from
**Southern
Water**

Your ref
BN/18/21/RES

Proposal: 5000 sq m of light industrial floor space (ClassB1 (b)/(c) following grant of outline planning permission WA/22/15/OUT (resubmission following BN/57/19/RES). This site is in CIL Zone 1 (Zero Rated) as other development.

Site: BN/18/21/RES: - GTR land east of Fontwell Avenue, Arundel Road, Arundel, BN18 0SB.

ARUN DISTRICT COUNCIL BN18/21/RES

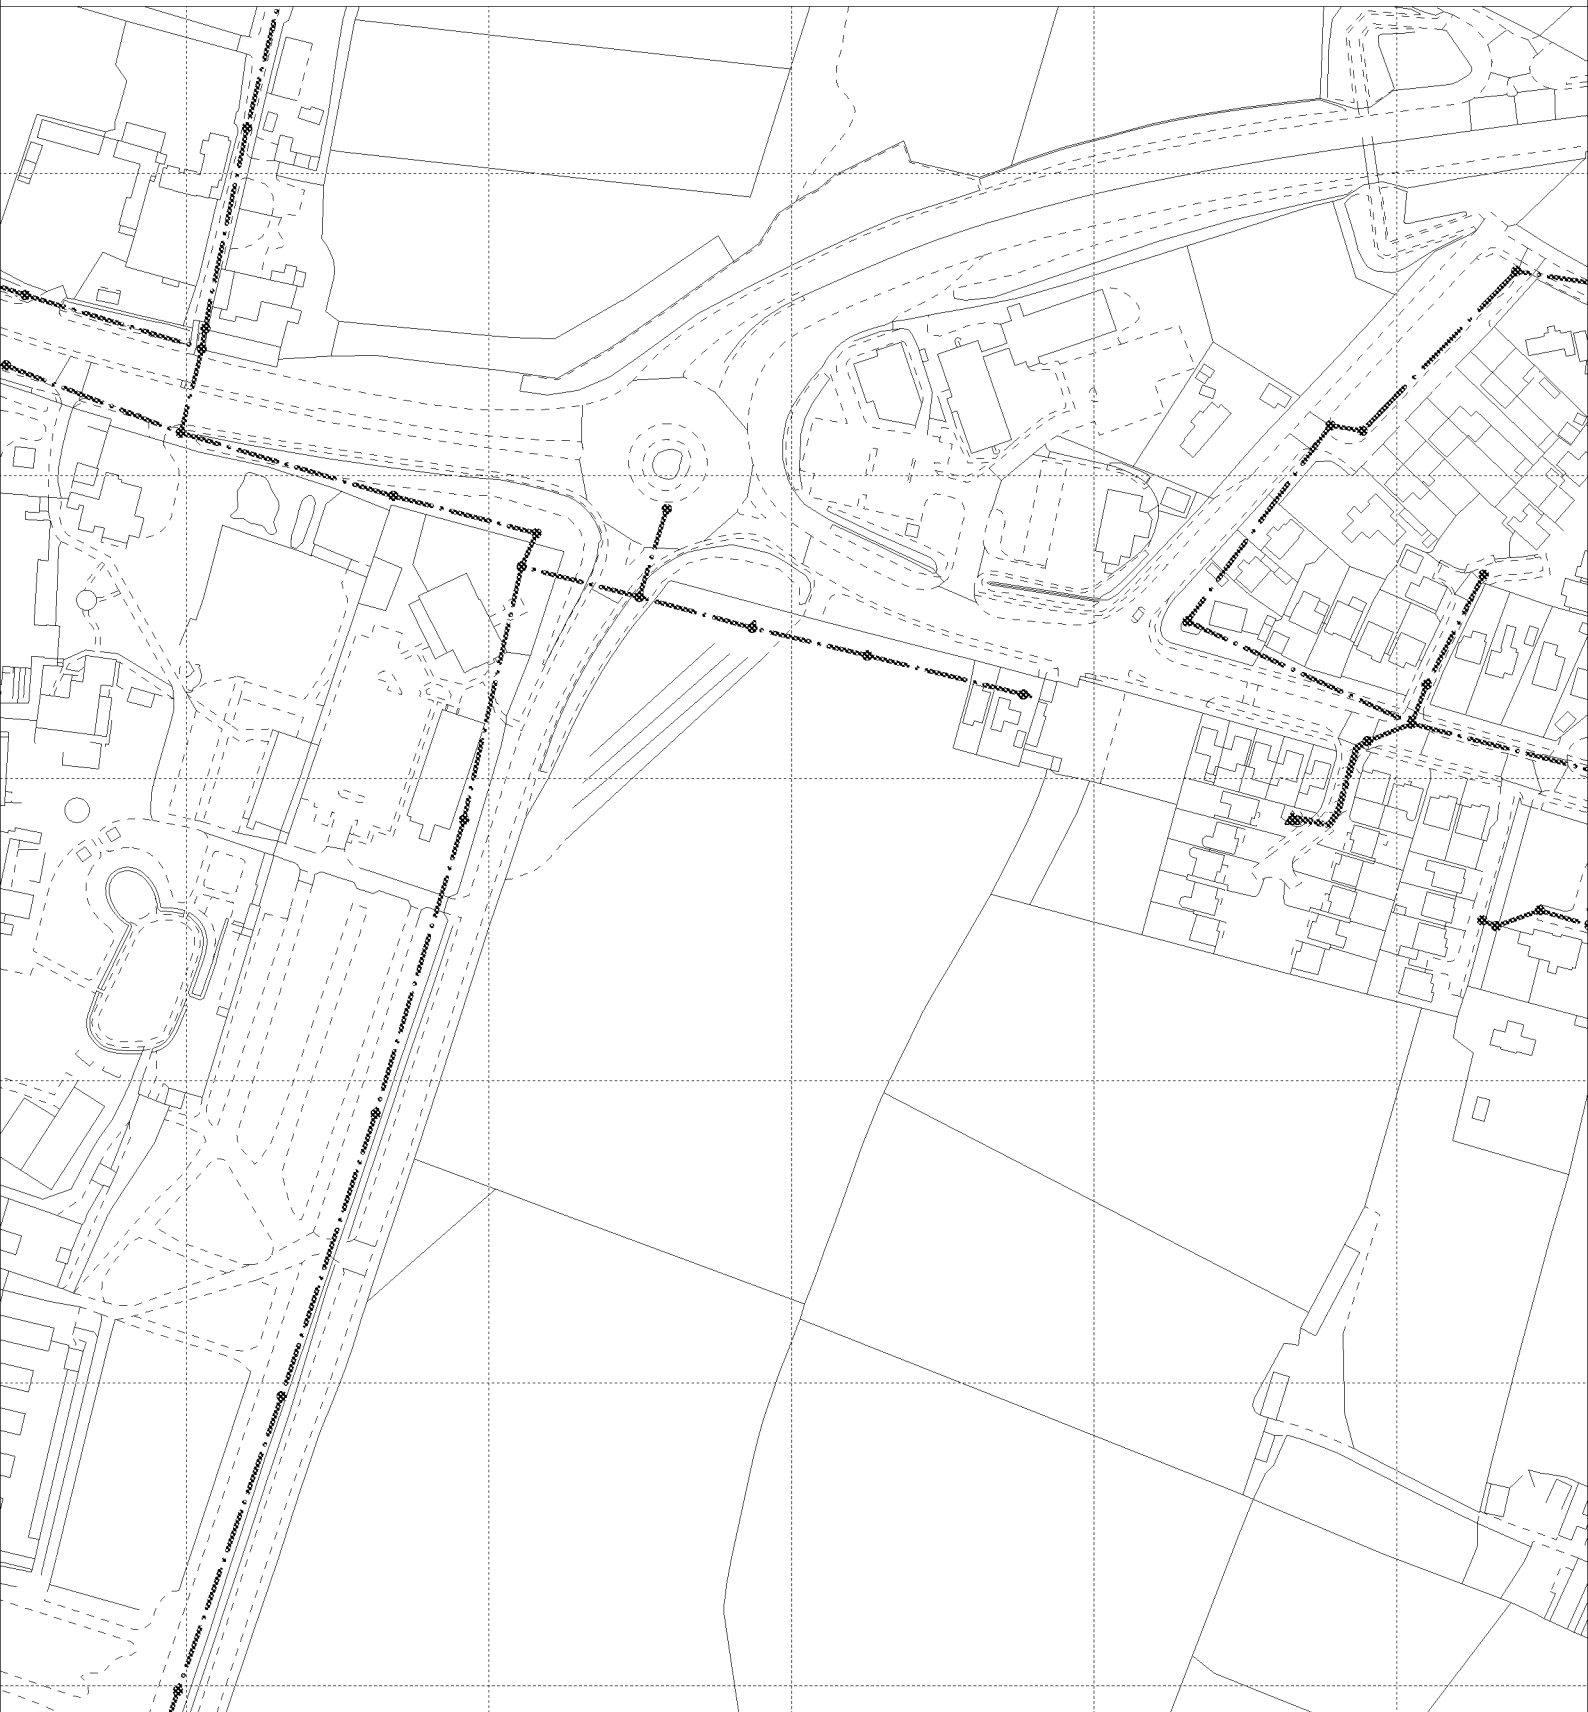
Please see the attached extract from Southern Water records showing the approximate position of our existing foul sewer within the development site. The exact position of the public asset must be determined on site by the applicant in consultation with Southern Water before the layout of the proposed development is finalised.

- The 150 mm diameter gravity sewer requires a clearance of 3 metres on either side of the gravity sewer to protect it from construction works and to allow for future maintenance access.
- No development or tree planting should be carried out within 3 metres of the external edge of the public gravity sewer without consent from Southern Water.
- No soakaways, swales, ponds, watercourses or any other surface water retaining or conveying features should be located within 5 metres of public or adoptable gravity sewers.
- All existing infrastructure should be protected during the course of construction works.
